TE Connectivity

Product Change Notification: PCN-25-239554

Terminal & Splice Products

Improving packaging for the interest of safety risk mitigation

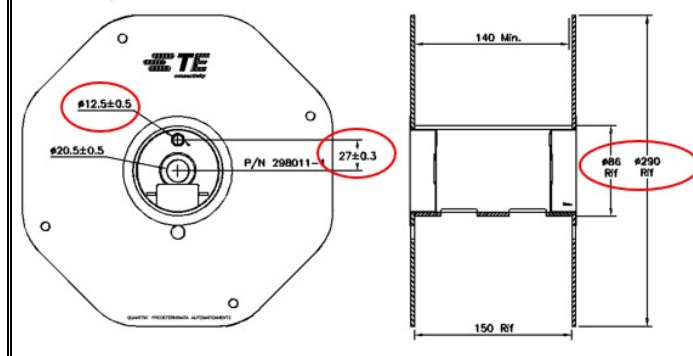
Sharp metal burr on the edge, potential safety risk and serrated edges with overlap

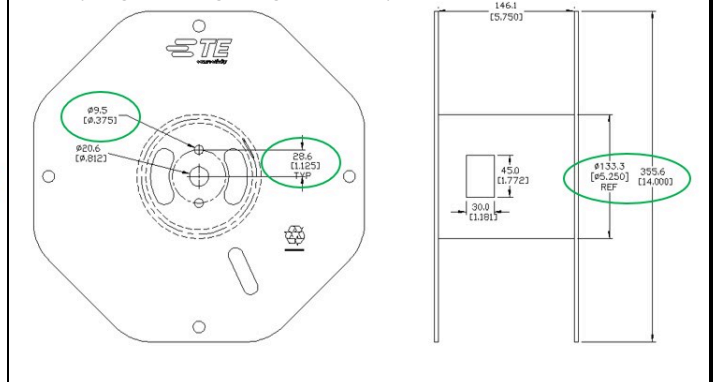
No sharp edges & straight edge no Overlap
